**RESPONSE TO REQUEST FOR ADDITIONAL INFORMATION**

**US-APWR Design Certification  
Mitsubishi Heavy Industries  
Docket No. 52-021**

**RAI NO.:** NO. 1045-7141 REVISION 3  
**SRP SECTION:** 03.08.05 – Foundations  
**APPLICATION SECTION:** 3.8.5  
**DATE OF RAI ISSUE:** 07/01/2013

**QUESTION NO. 03.08.05-52:**

**Figure 1: Section Cut of R/B Complex Basemat**

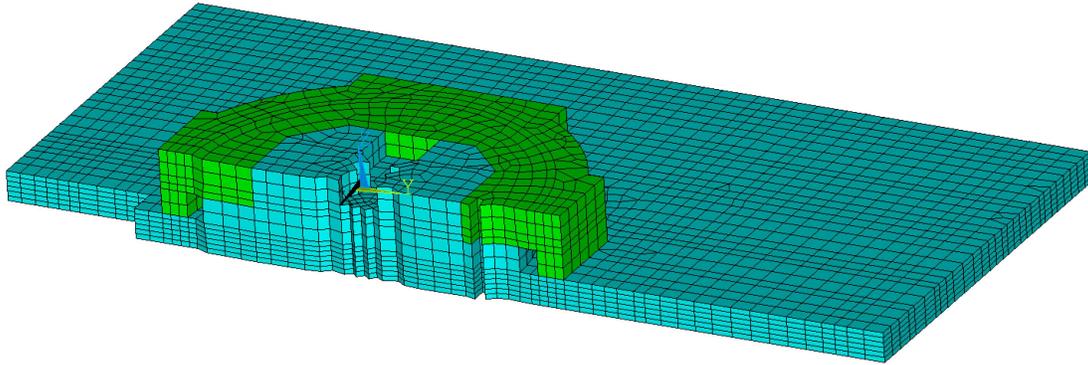
In Subsection 3.8.5.4.2.1, “Global Three-Dimensional FE [finite element] Modeling of Basemat,” the third paragraph (Page 3.8-99) states that “The upper portion of tendon gallery is conservatively modeled using a concrete strength of 5,000 psi to simplify design while providing for the potential in variation of construction joints.”

It is not clear to the staff how using a concrete strength of 5,000 psi, which is less than the actual design strength of 7,000 psi, for the mathematical modeling, is conservative; and also provides for the potential in variation of construction joints. The applicant is requested to use 7000 psi of concrete strength for the upper portion of the tendon gallery; or explain the purpose of using the 5000 psi concrete more clearly.

The analysis of the basemat foundation explicitly models concrete compressive strengths of 5,000 psi, in addition to 7,000 psi at tendon anchorage assembly locations (within the central thickened portion of the basemat) as it will be built by the combined license (COL) applicant for both the general basemat and tendon gallery areas. Both 5,000 and 7,000 psi concrete were modeled to account for potential stress concentrations due to varying material properties. Refer to Figure 1 (provided on the following page of this response) for a diagram of a section cut through the reactor building (R/B) complex basemat taken from the three-dimensional finite element model. Conservatively, computations for reinforced concrete design consider a lower bound concrete compressive strength of 5,000 psi only.

The R/B complex basemat is modeled with a concrete strength of 5,000 psi except for the upper portion of the tendon gallery which is modeled with a concrete strength of 7,000 psi. This modeling of the basemat and tendon gallery matches the concrete strength construction requirements for these areas.~~The upper portion of tendon gallery is considered with concentrated stresses created by the connection with the PCCV. This region is divided into multiple layers of elements in the radial direction to accommodate the differing concrete strengths in this area as shown schematically in Figure 3.8.5-4. is conservatively modeled using a concrete strength of 5,000 psi to simplify design while providing for the potential in variation of construction joints.~~
